SERVICE BULLETIN

SB No. 68 Issue No. 2

TITLE
CANOPY LATCH CORRECT OPERATION INSPECTION
CLASSIFICATION

T67C, T67M and T67M200 Aircraft, Post Mod M129 (Split Canopy), T67M-MkII, T67M260 and T67M260-T3A.

Fig 1

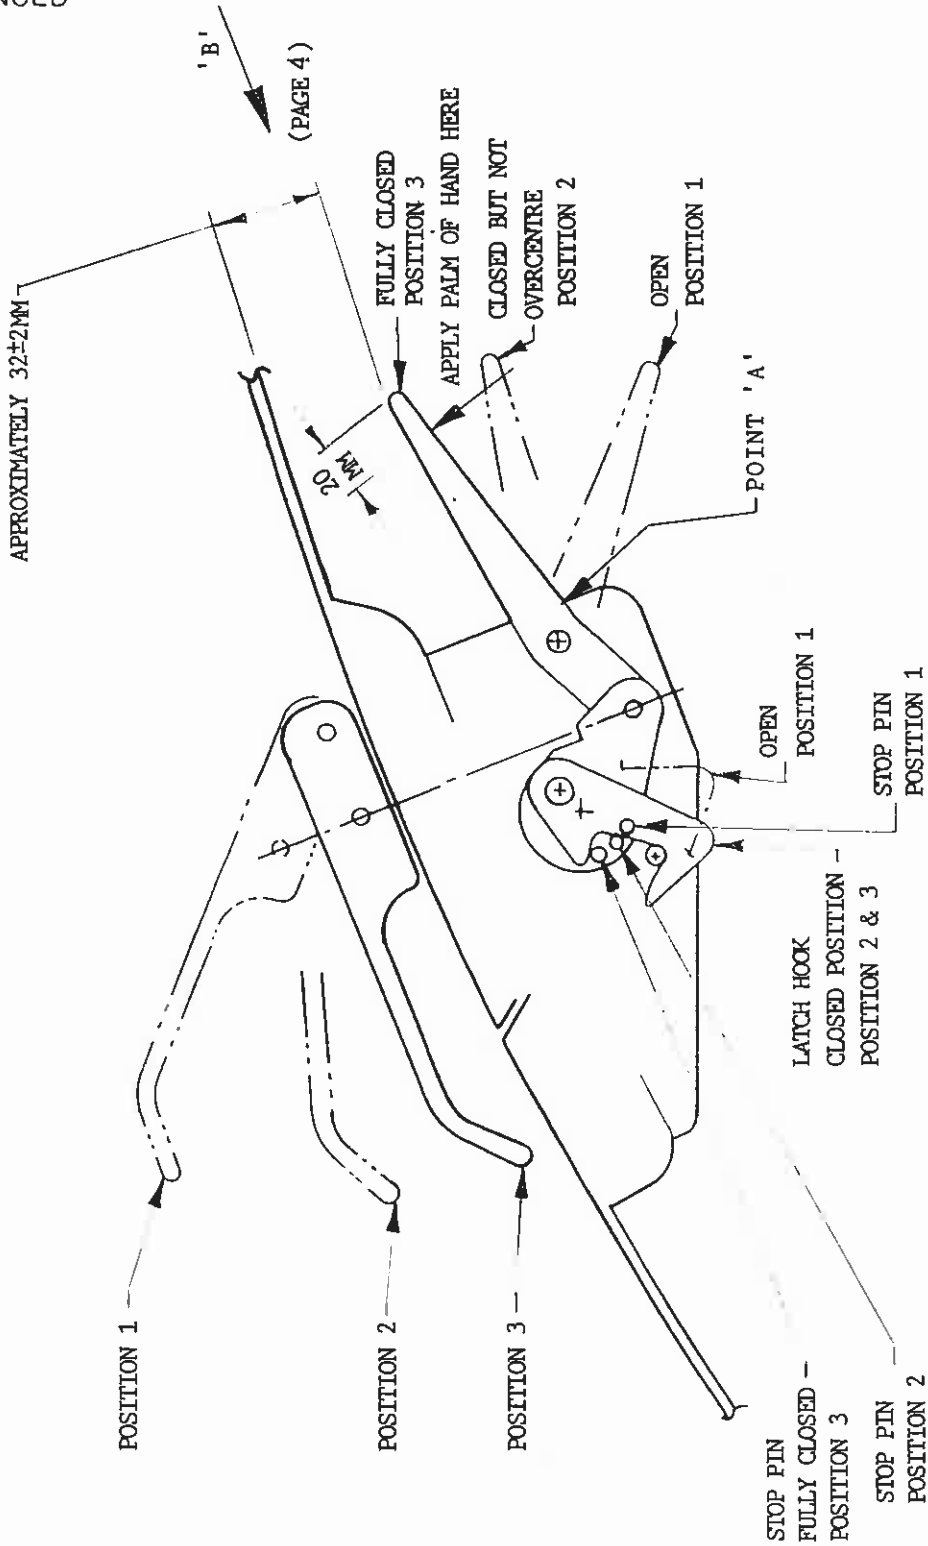
An incident has occurred where the canopy latch was apparently closed correctly but when engine revs were increased beyond 1500 RPM the canopy opened.

Fig. 1 page 2 shows 3 positions of the canopy mechanism:

Position 1 - Open/Unlatched

Position 2 - Latched but mechanism not over centre

Position 3 - Correctly closed, mechanism fully over centre.

- (i) Remove canopy mechanism and latch covers
- (ii) Close canopy fully. Ensure internal handle is in its correct position (Ref Fig.1).
- (iii) Check that stop pin is just touching latch hook. If not adjust in accordance with Maintenance Manual, Section 3, paragraphs 3.2.
- (iv) Check closure. By positioning palm of hand at point indicated, ref. Fig. 1, push up latch handle, which should close with reasonable resistance but without using excessive force.
- (v) Replace mechanism and latch covers, in accordance with Maintenance Manual, Section 3, paragraphs 3.2.
- (vi) Maintenance Manuals to be amended to reflect points contained in (ii), (iii) and (iv).

FIG 2
VIEW ON ARROW 'B' (REF FIG 1)

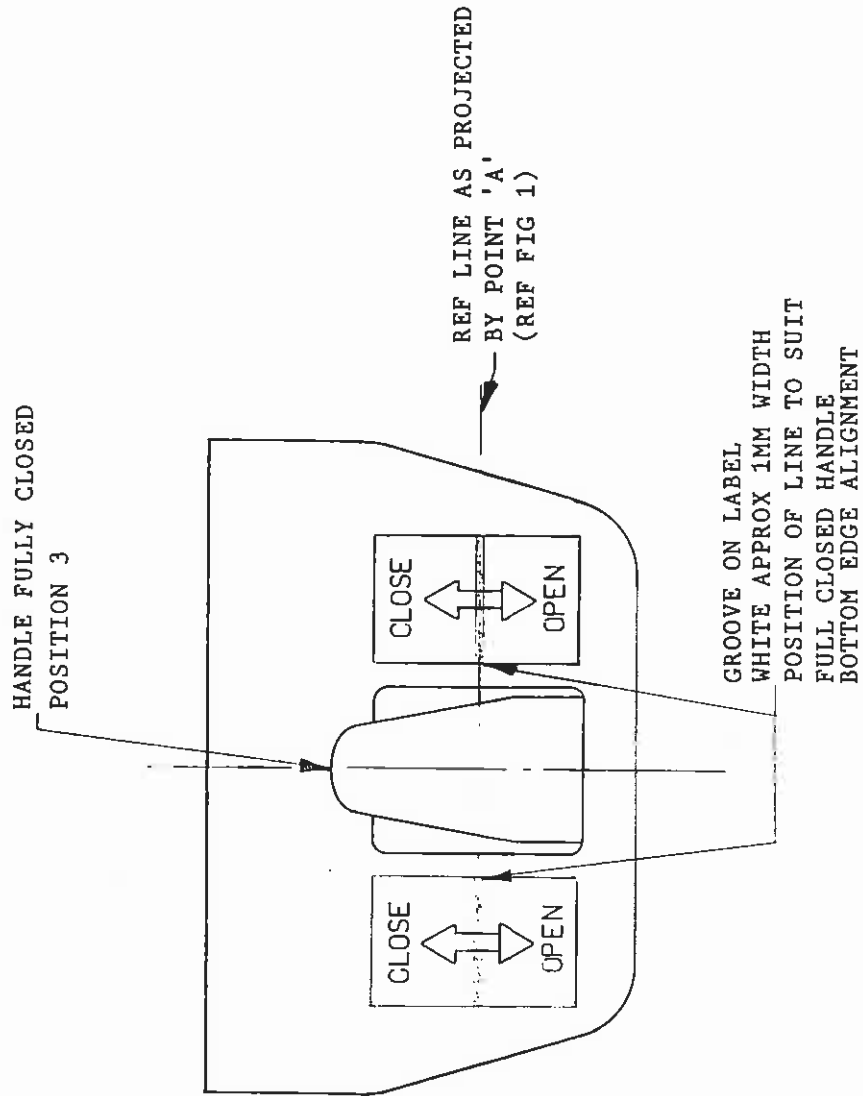
- (vii) When handle is fully closed, ie meets requirements of Fig. 1, mark a white line across both labels ref. Fig. 2 on line with handle lower surface (ie coincident with Point 'A' ref Fig. 1 & 2. The line may be obtained by running a hacksaw across both labels; a) deep enough to reveal white of label material or b) if base material is red, deep enough to hold white fill in wax, ie 0.25mm to 0.5mm.

When label is marked, it is to be identified in IPC Ref. Chapter 15 as Part No. T67M-17-351 Post Mod M666, Part No. T67M-17-319 to be annotated Pre Mod M666.
